HYDROGRAPHIC TITLE SHEET

H-9724

Locality HILLER COVE TO INDIAN NECK

DESCRIPTIVE REPORT
TO ACCOMPANY SURVEY

Marsh

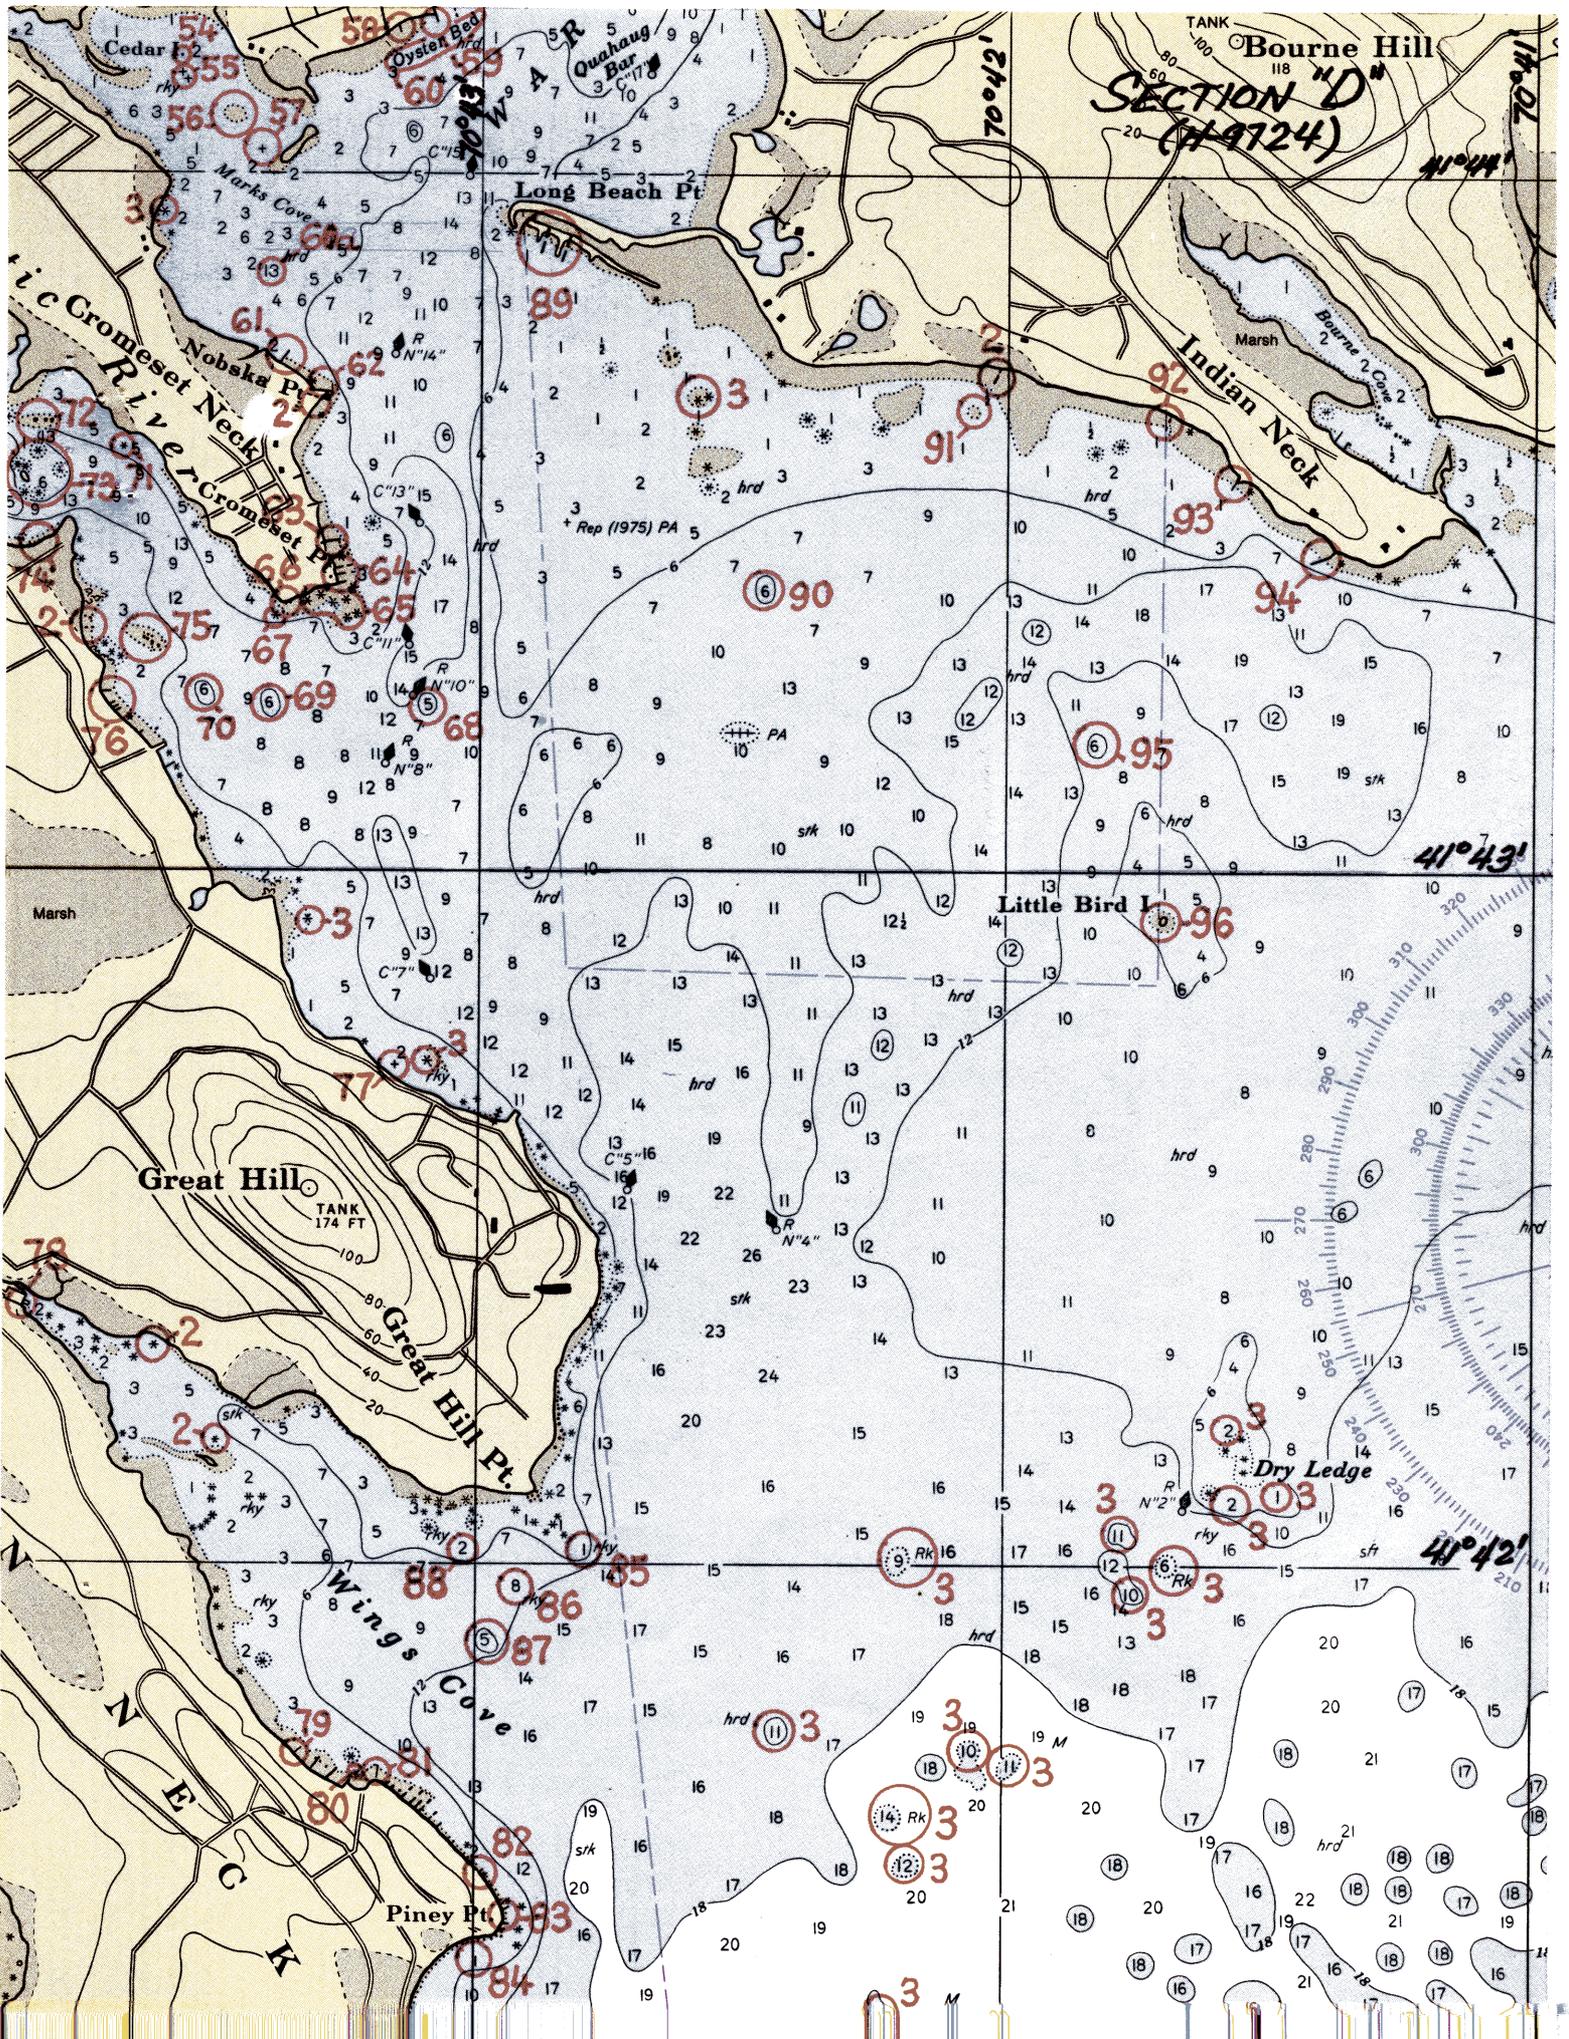
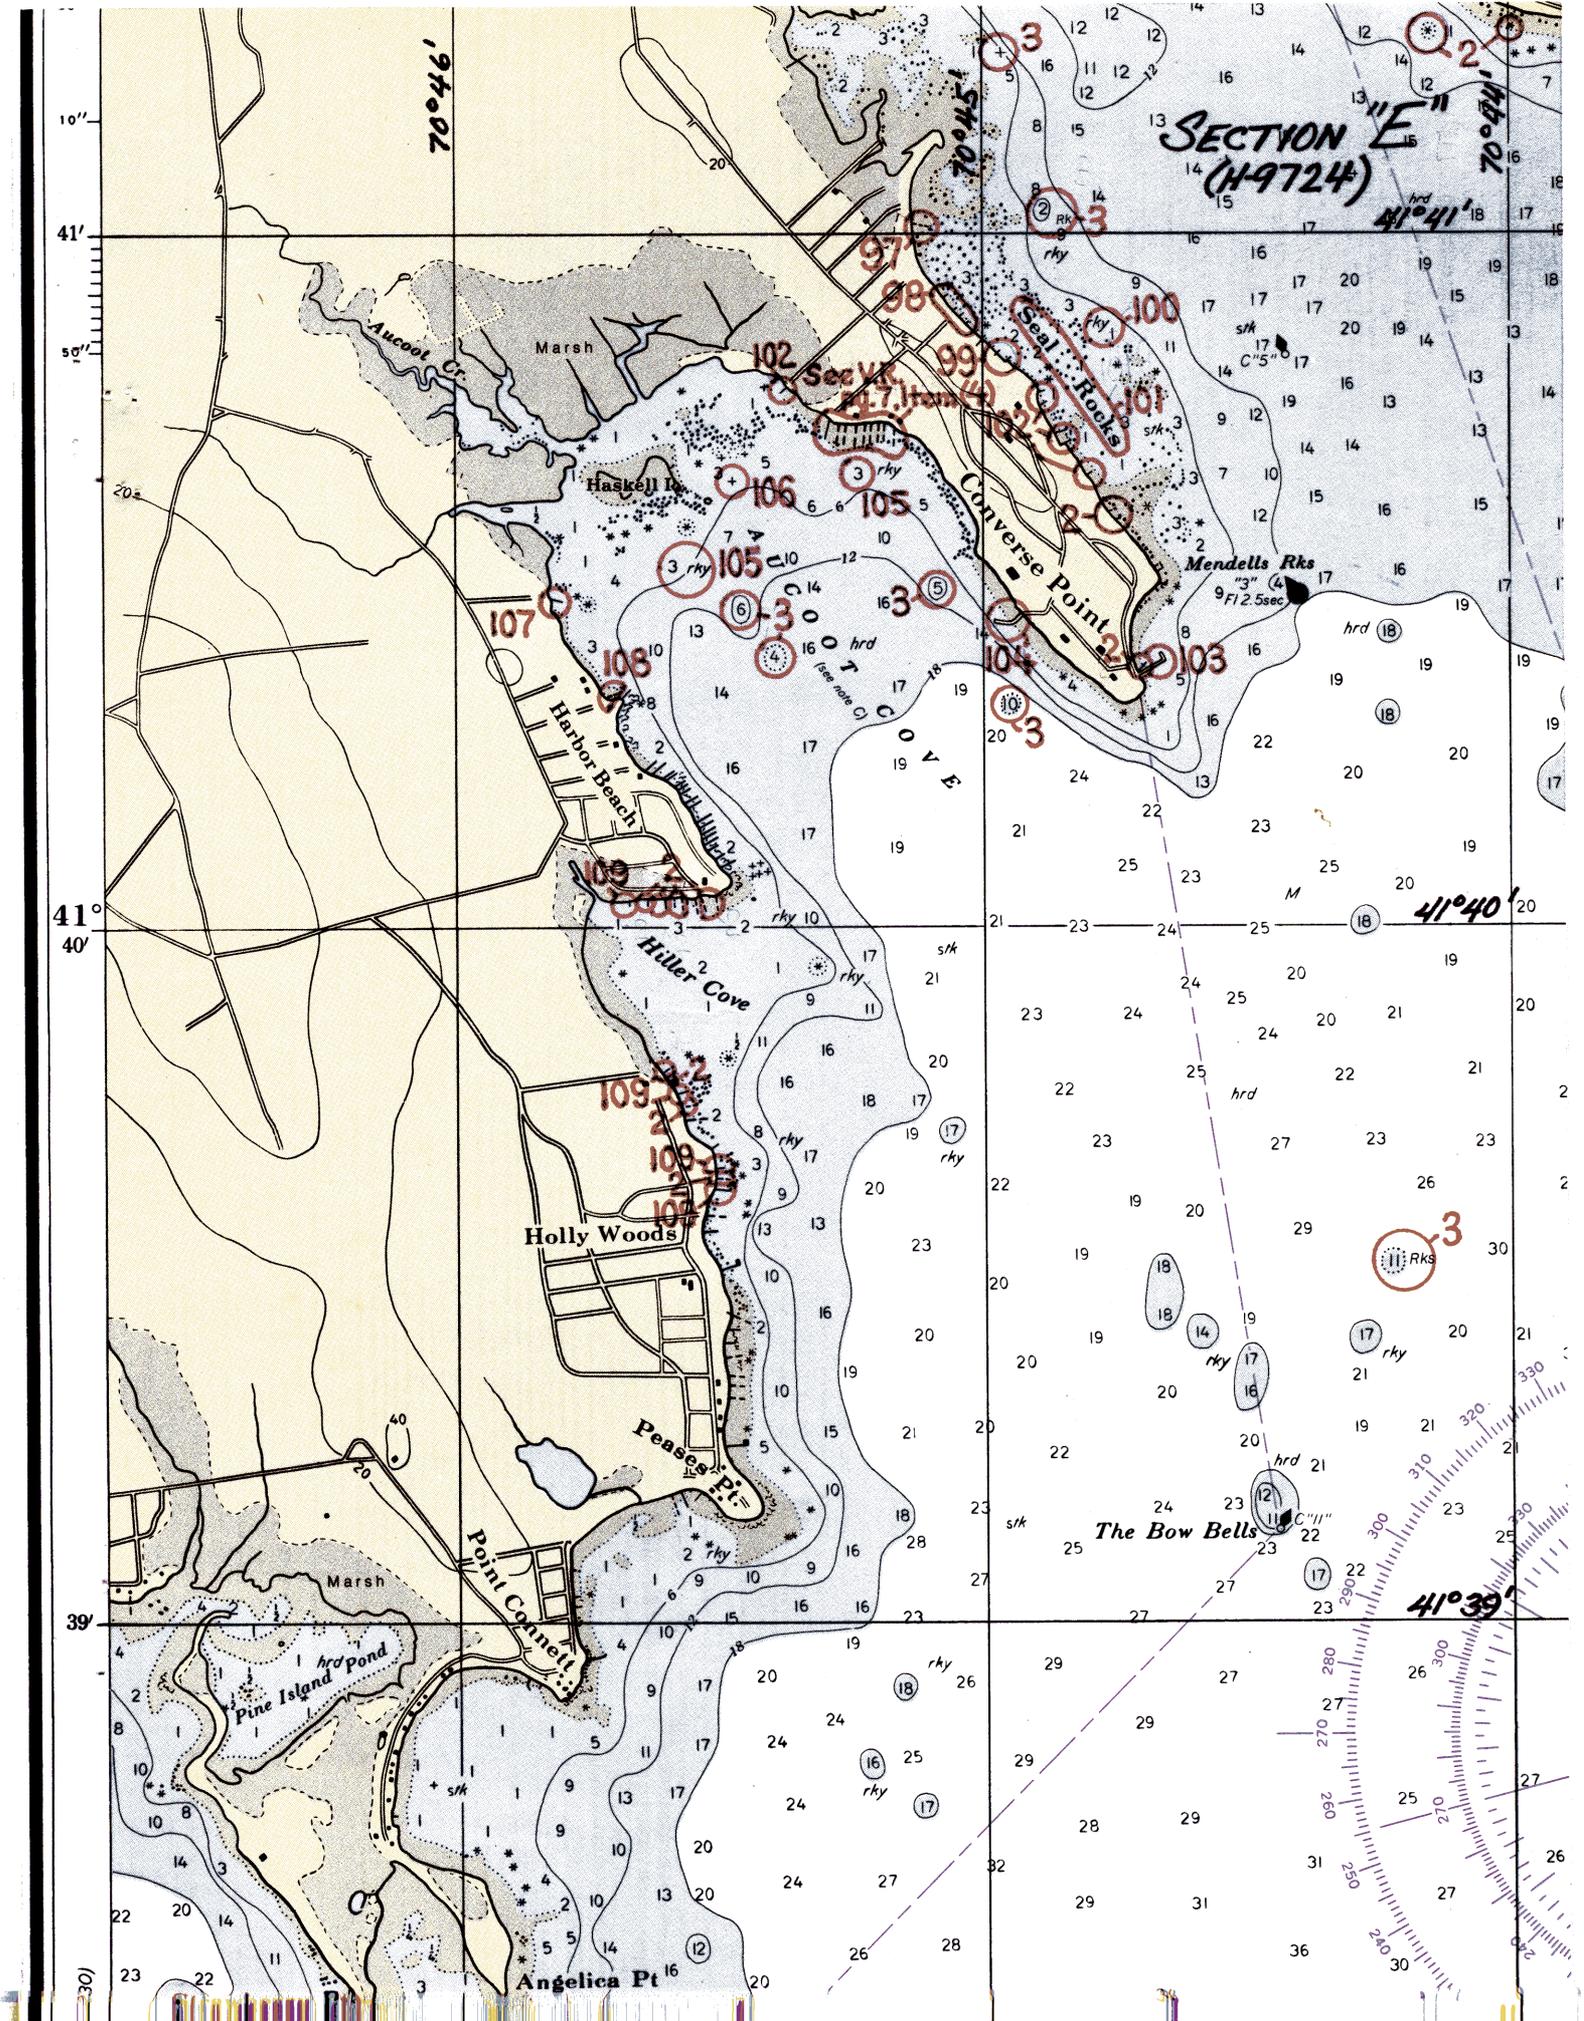
24. A comparison between the present survey and Chart 13236, 21st Edition, dated June 27, 1981, was made during quality control inspection in order to provide additional guidance to the nautical chart compiler. Many charted items have not heretofore been addressed. The attached six chart sections contain numbered items cross-referenced to the following numbered recommendations:

(9) The geographic name "Quasuet Pt." is mistakenly charted as "Quasuet P"--revise the new chart edition accordingly.

- (20) Pier is charted from a miscellaneous source. Shoreline change suggests cultural improvements in this area. Recommend expunging the charted pier.

- (25) The delineation of the "L" pier, charted from a miscellaneous source, is in conflict with the delineation shown on TP-00764 (1974-79). The Class I map delineation is considered questionable. A charting resolution is deferred to the chart compiler.

(60a) A 13-foot sounding or soundings of 1 and 3 feet is/are charted from a miscellaneous source. Expunge the questionable item and chart depths in the area as shown on the present survey.

(74) The pier and questionable marks connected to the shoreline are charted from a miscellaneous source. Chart the area as shown on the present survey.

(84 and 85) One-foot soundings charted from H-2272 (1896) are labeled "rock" on their source. Rocks awash, covered 1 foot at MLW, were carried forward to the smooth sheet. Chart the appropriate symbol instead of the 1-foot soundings.

(86) The 8-foot sounding, charted from H-2272 (1896), is labeled "rock" on the original source. The 8-foot sounding with "Rk" appended was carried forward to the present survey and should be charted as shown on the smooth sheet.

(88) The 2-foot sounding charted from H-2272 (1896) is labeled "rock" on the original source. This item was carried forward to the smooth sheet as a 2-foot sounding with "Rk" appended and should be charted as such.

- (100) The 1-foot sounding, charted from H-2272 (1896), is identified on the original source as a rock. A rock covered 1 foot at MLW was carried forward to the smooth sheet. Chart the appropriate rock symbol.

- (101) The geographic name "Seal Rocks" is charted in vertical letters denoting bare rocks. There are no bare rocks on the present survey in this area. Revise the charted letters from vertical to slanted.

- (104) Revise the charted double line delineation of this item to a single line delineation as shown on the present survey.
- (105) The 3-foot sounding, charted from H-2272 (1896), is identified as a sunken rock on the source. A 3-foot sounding with "Rk" appended was carried forward to the smooth sheet and should be charted as such.

- (108) Ruins originate with a pier on T-2215 (1895). The charted ruins are not noted in the present survey records and fall within a foul area delineated on the smooth sheet. A charting resolution is deferred to the chart compiler.

- (112) The 2-foot sounding, charted from H-2272 (1896), is identified on the original source as a rock. The 2-foot sounding with "Rk" appended was carried forward to the smooth sheet and should be charted as shown on the smooth sheet.

- (113) Chart the locations of the groins as shown on the present survey.
- (114) The 1-foot sounding, charted from H-2272 (1896), is identified as a rock awash covered 1 foot at MLW on the original source. This rock awash was not shown on the smooth sheet since it falls within the limits of a foul area delineated on the smooth sheet.

- (121) Chart locations of rocks awash in this area as shown on the present survey.
- (122 through 124) The 17-, 2-, and 4-foot soundings charted from H-2272 (1896) are identified on the original source as submerged rocks. The three soundings with "Rk" appended to each were carried forward to the smooth sheet and should be charted as shown on the smooth sheet.

- (125) The 16-foot sounding, charted from H-3391 (1912-14) WD, is identified on the original source as a submerged boulder. The 16-foot sounding with "Bld" appended was carried forward to the smooth sheet and should be charted as shown on the smooth sheet.
